ALERT SERVICE BULLETIN

NO. 214-03-66

MODEL AFFECTED: 214B/214B-1

SUBJECT: TAIL ROTOR BLADE, P/N 214-015-750-005, -109, AND -113, TIP CLOSURE INSPECTION

FIGURE 1

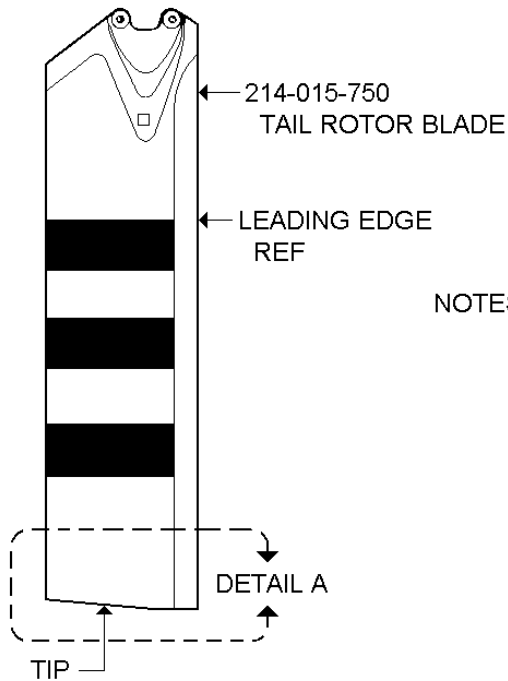
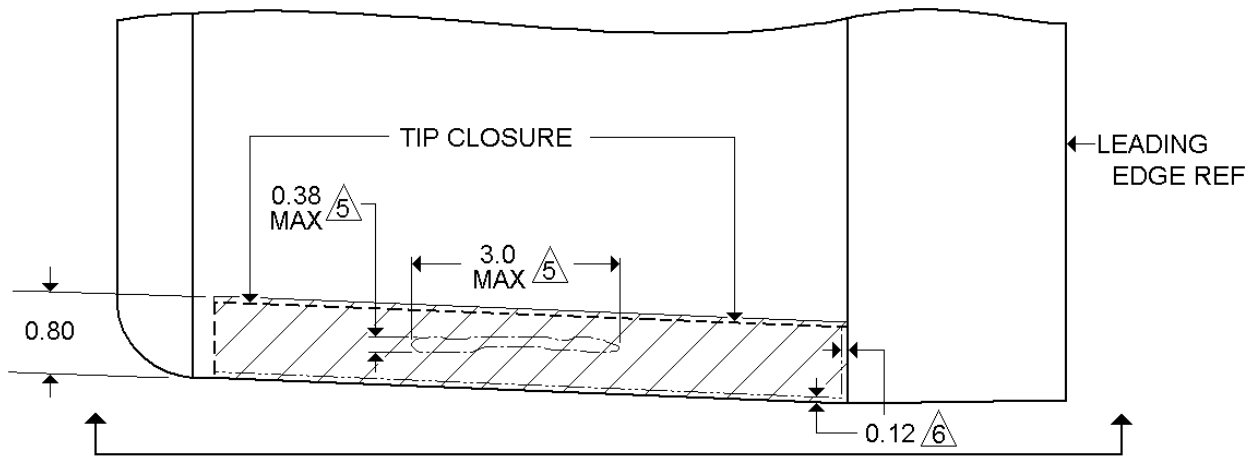
- b. Spare blades - prior to installation and then at each 50 flight hours thereafter until the blade is retired from service.
3. Refer to Figure 1. Using suitable material clean the tip closure and the skin area at the tip of each blade in the area to be inspected.

- a. Visually inspect for cracks or voids in the tip closure to skin and in the tip closure to tip block bond lines. Cracks or visible edge voids are cause for removal of the blade.

- b. Tap inspect for voids between the upper and lower skins and the tip closure along the length and width of the closure:
 - 1) Tap using a large coin (20 mm diameter minimum) with a tapping frequency of 3-6 taps/second, making sure that the entire area shown in Figure 1 is inspected.

- 2) Areas that are well bonded will distribute the tapping sound to the entire structure. Any voided areas will isolate the tapping sound locally to the void area – the sound will not seem as loud.

- 3) Map any void areas to determine size.
 - c. Voids between the skin and tip closure which are 0.38 inch spanwise width by 3.0 inch chordwise length, and smaller, are acceptable as long as they are not within 0.12 inch of the skin edge. Voids larger than those noted or within 0.12 inch of the skin edge are cause for removal of the blade. Voids within one inch of each other shall be considered as one void.

- NOTES: 1. FIGURE NOT TO SCALE.
 2. ALL DIMENSIONS IN INCHES.
 3. INSPECT FOR CRACKS AND VOIDS AT BOND LINES.
 4.  TAP INSPECTION AREA UPPER AND LOWER SKIN.
 5. MAXIMUM ALLOWABLE VOID DIMENSIONS. VOIDS WITHIN 1.0 INCH OF EACH OTHER SHALL BE CONSIDERED AS ONE VOID.
 6. VOIDS MAY NOT BE WITHIN 0.12 INCH OF SKIN EDGE.
